PLANNING AND ZONING COMMITTEE MINUTES:

March 20, 2018

Chattanooga Form-Based Code

Proposed Amendments

30) Parking Maximums

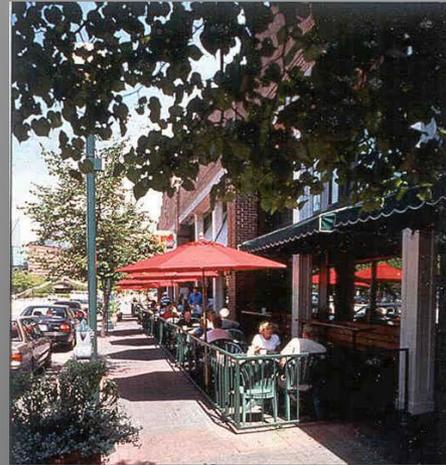
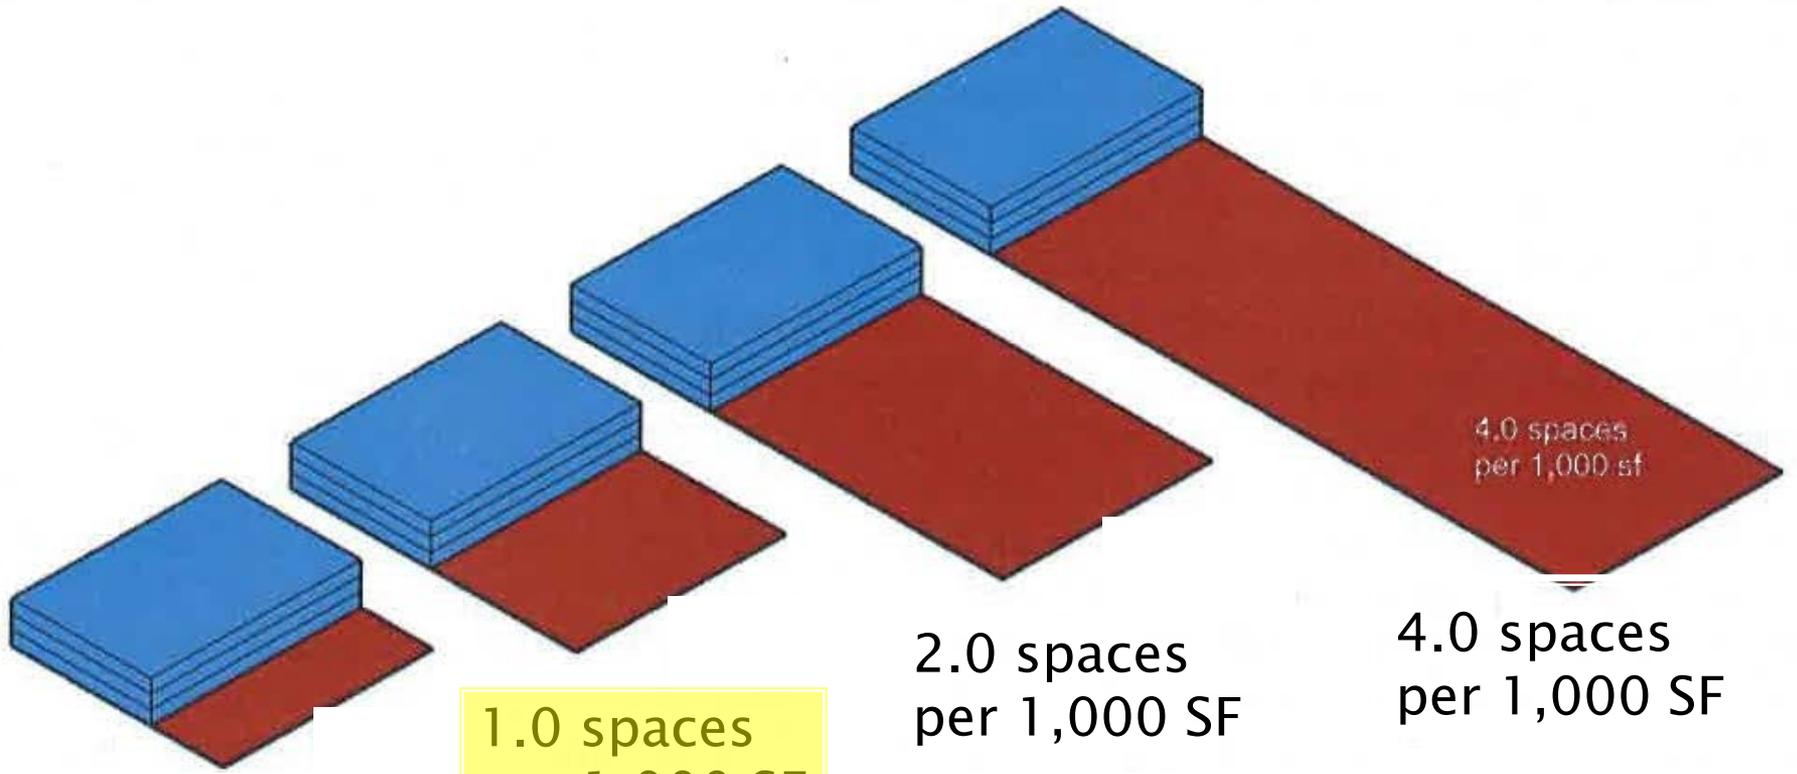
- ▶ Maintain parking minimums.
- ▶ No more than 20% over the required number of spaces
- ▶ Maximum would not apply to:
 - Shared Parking
 - Public Parking
 - Structured Parking

- ▶ No parking maximums

31) Perimeter Parking Lot Landscaping

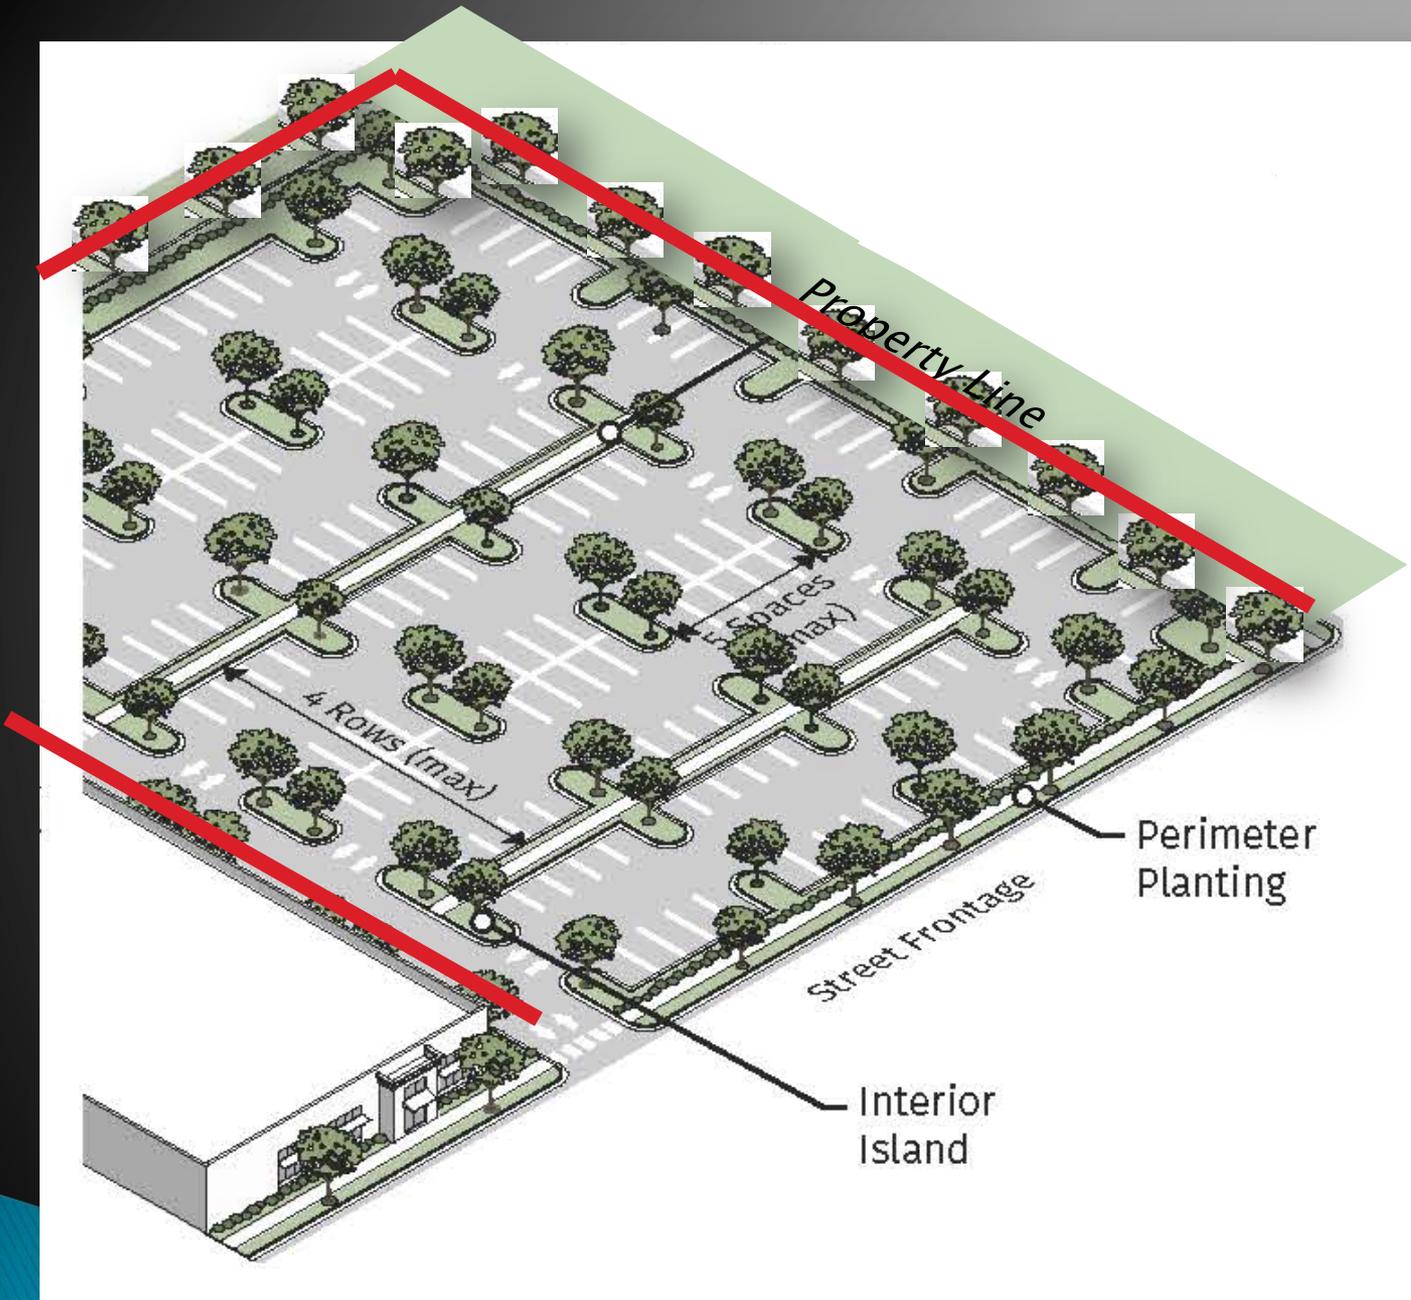
- ▶ Not required next to the building

- ▶ Not required for any rear parking areas
- ▶ Only required when fronting a street

35) Ground Floor Elevations

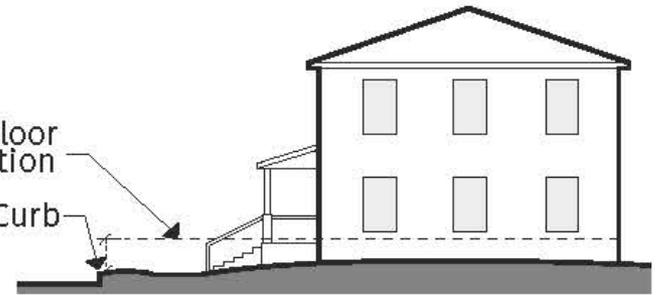
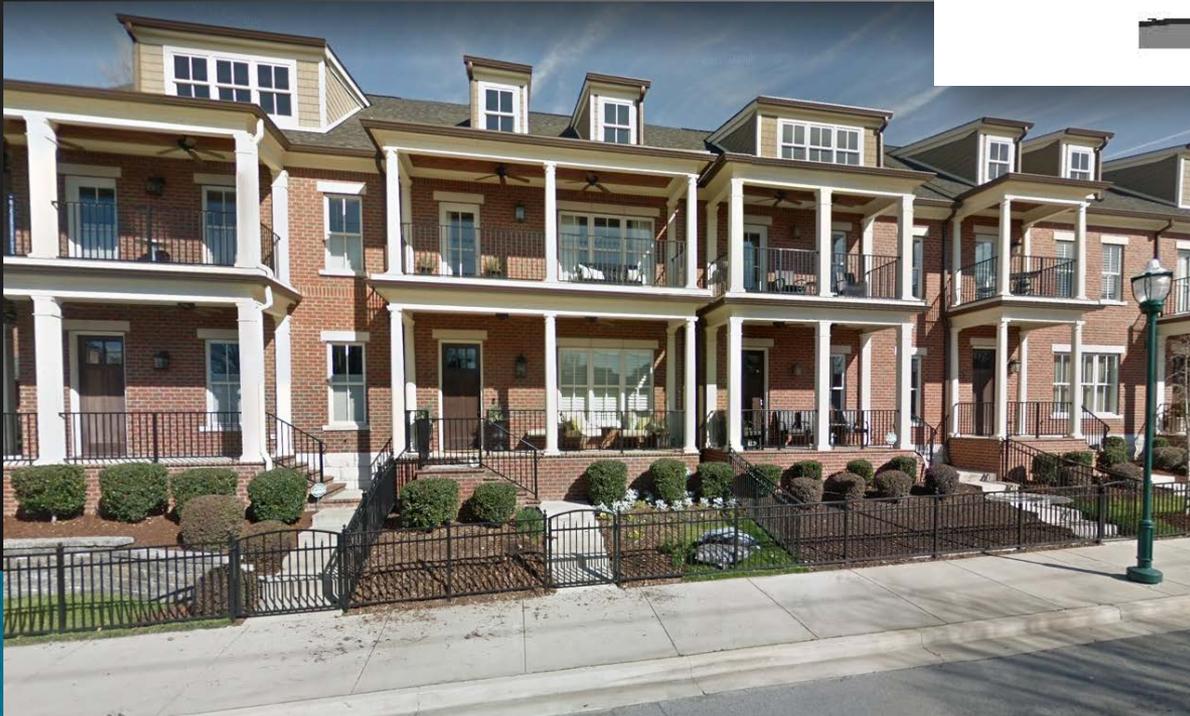
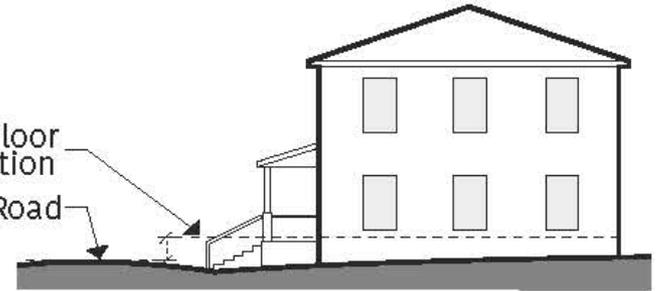
- ▶ No change to the current FBC

- ▶ Remove the minimum ground floor elevation requirement of 16 inches

36) “Protected Zone” Buffer when next to RA Zones

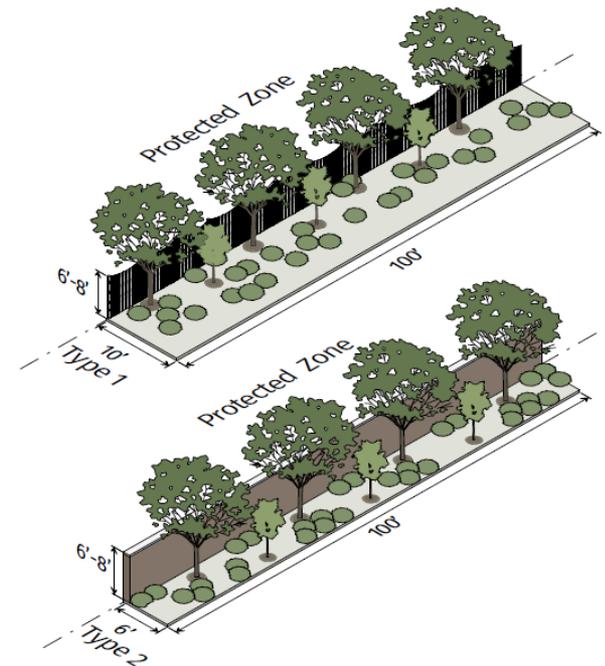
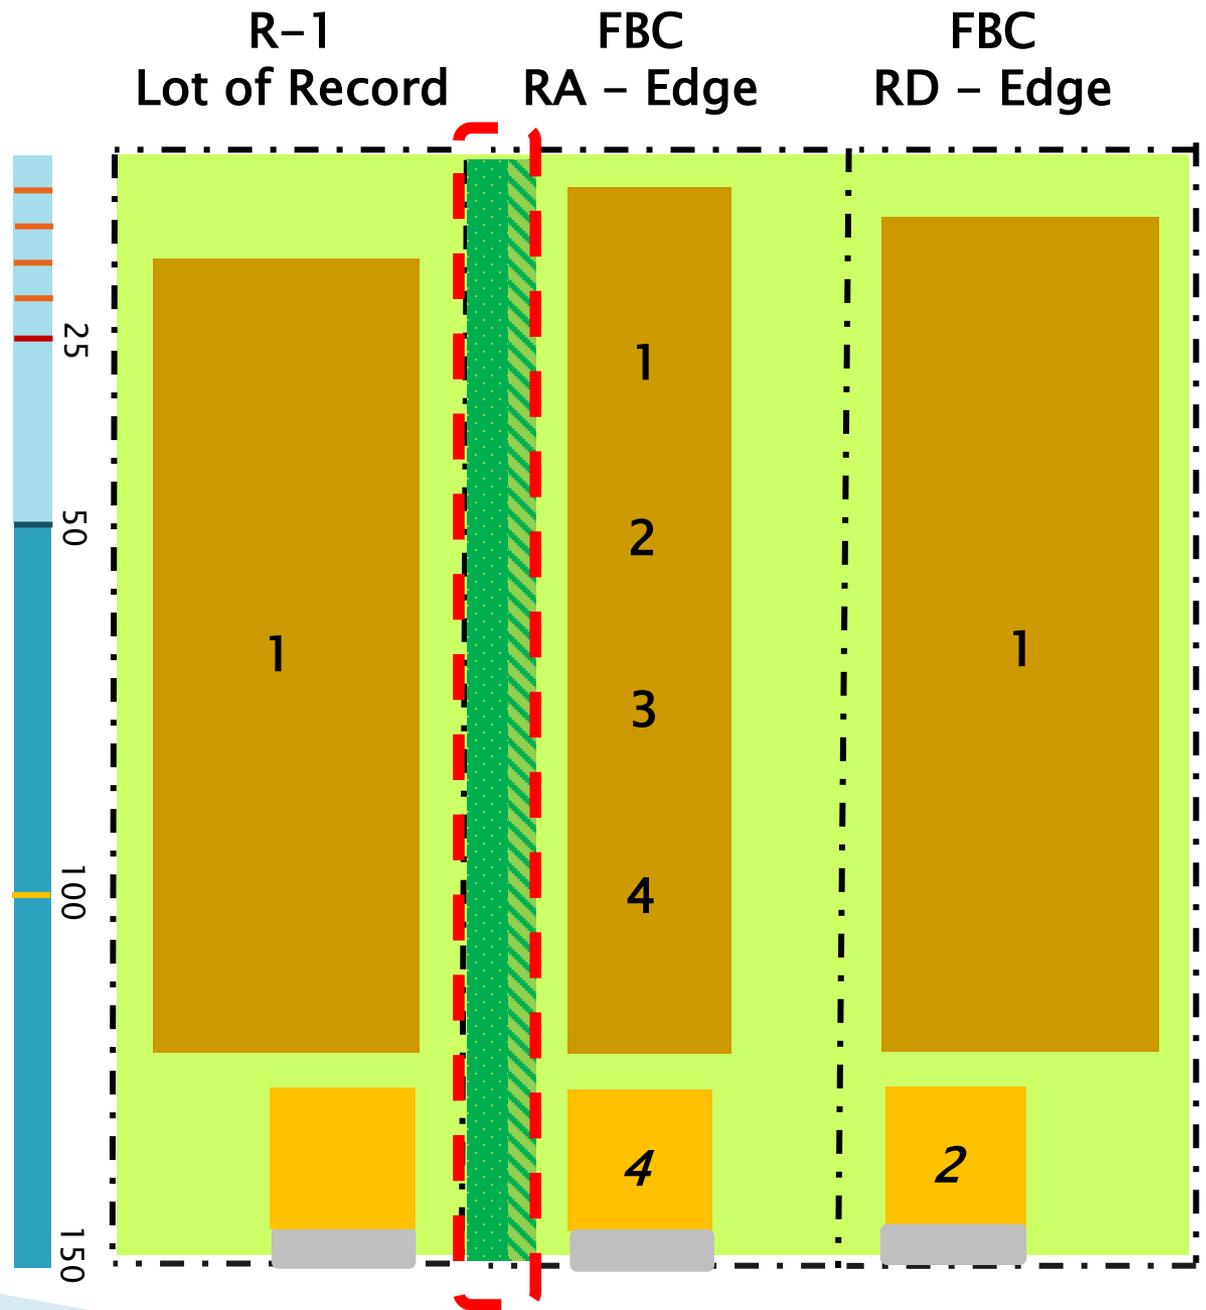
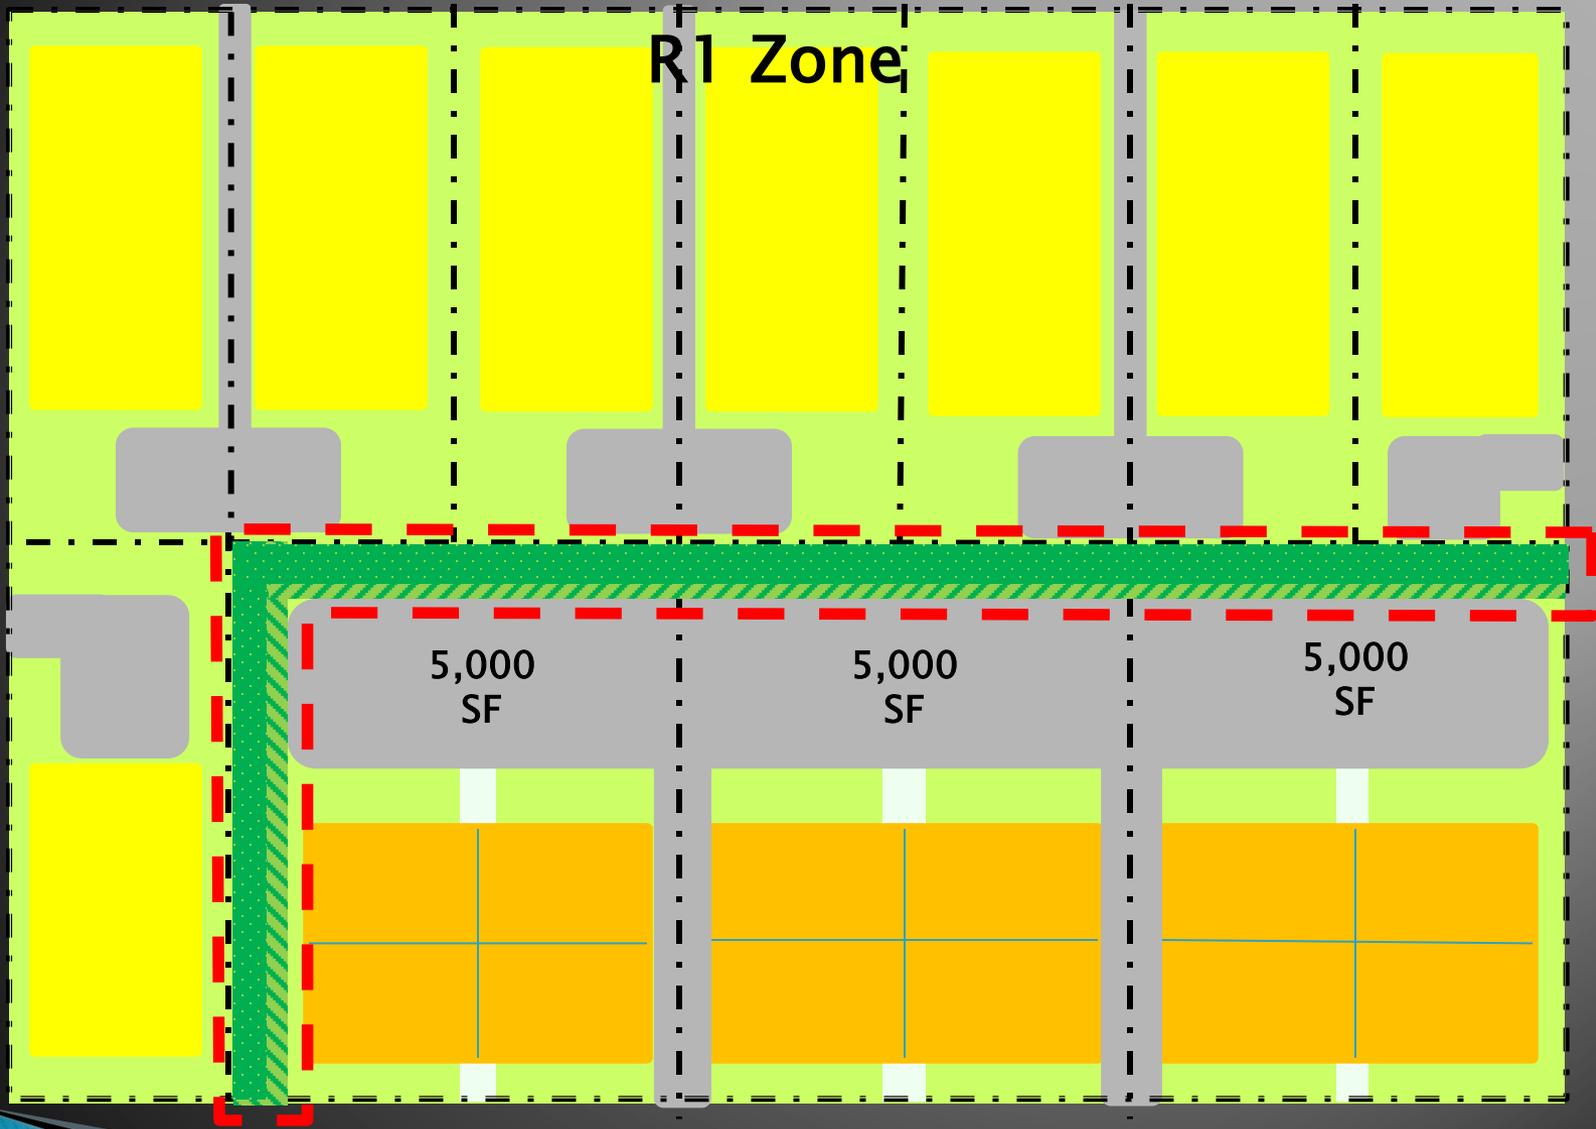
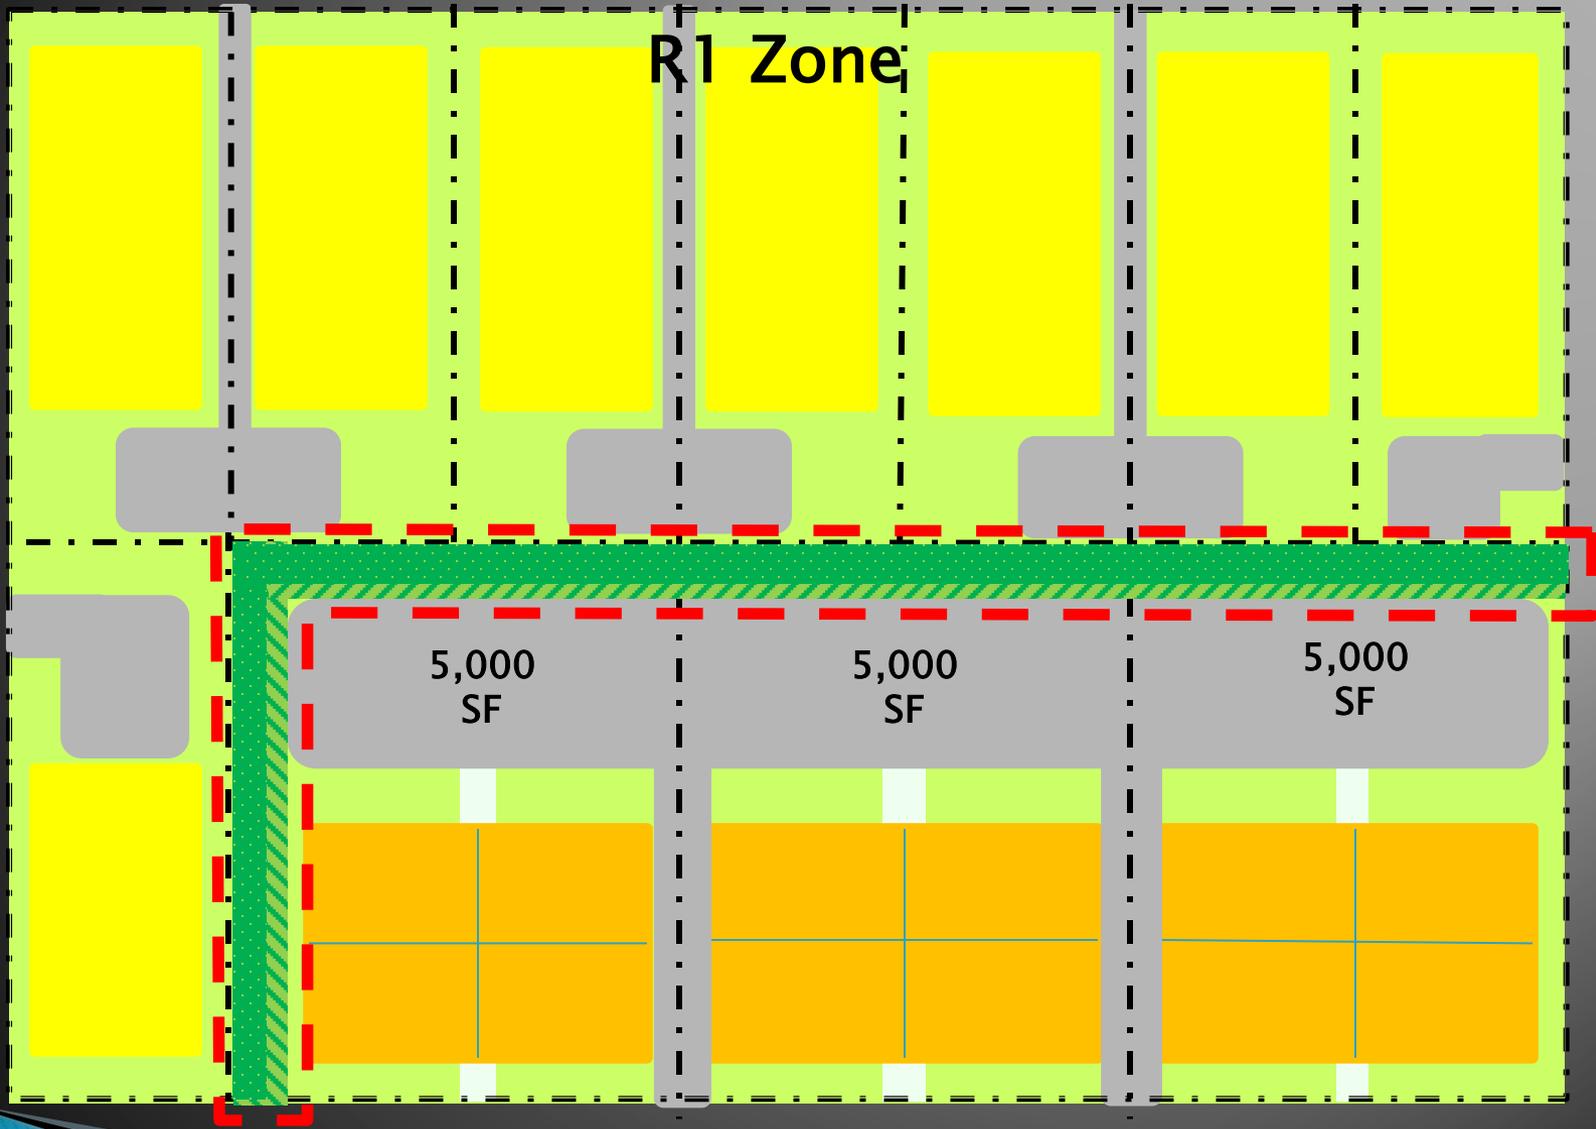
- ▶ Remove landscape buffer requirement for R-1 zone (like RD); 15 feet setbacks would still apply

- ▶ “Multiple platted lots contained on a single site plan, under one owner or development entity, and any parking areas connected with drive aisles, are not exempt from this buffer requirement.”
